**FINAL DRAINAGE REPORT
FOR
ELECTRONIC STORAGE
LOT 2 MOUNTAIN STATES PIPE AND SUPPLY
7765 ELECTRONIC DRIVE
COLORADO SPRINGS, COLORADO**

ELECTRONIC STORAGE SITE DEVELOPMENT PLAN PROPOSED DRAINAGE MAP MARCH 2020

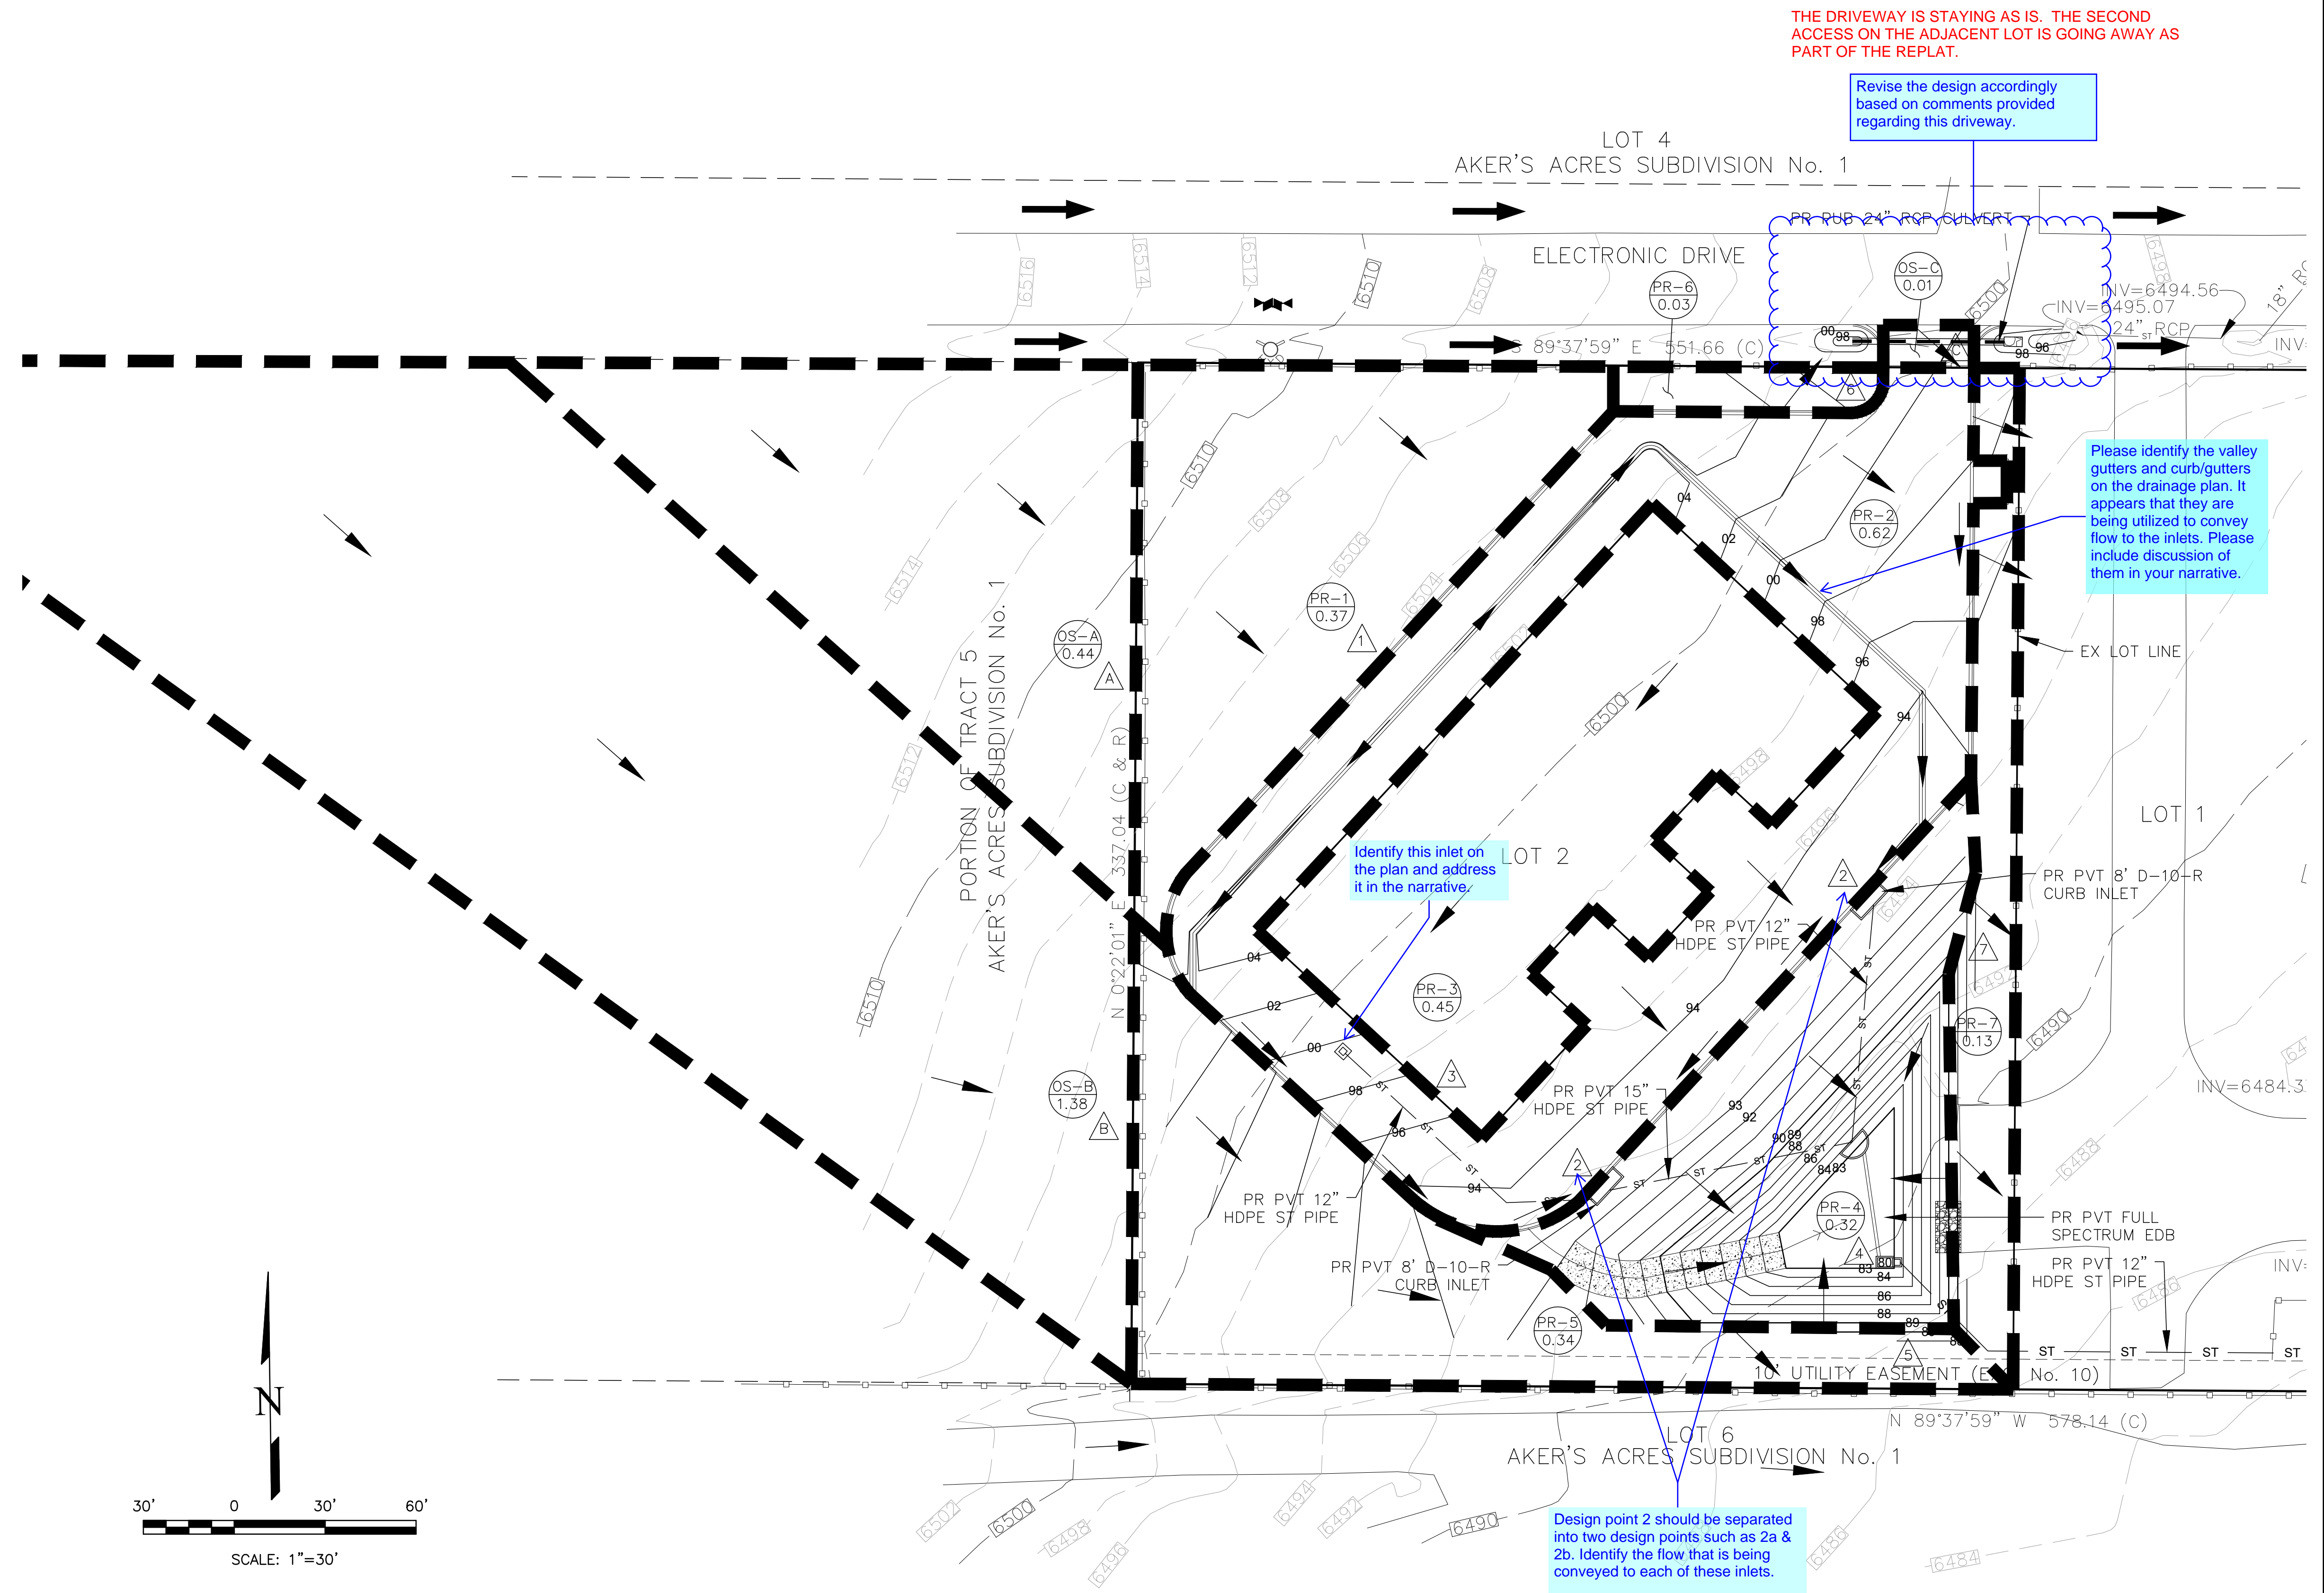
Please identify this design point on the drainage plan. I could not find it on the plan

Revise the design accordingly based on comments provided regarding this driveway.

Please identify the valley gutters and curb/gutters on the drainage plan. It appears that they are being utilized to convey flow to the inlets. Please include discussion of them in your narrative.

Identify this inlet on the plan and address it in the narrative.

Design point 2 should be separated into two design points such as 2a & 2b. Identify the flow that is being conveyed to each of these inlets.

THE DRIVEWAY IS STAYING AS IS. THE SECOND ACCESS ON THE ADJACENT LOT IS GOING AWAY AS PART OF THE REPLAT.
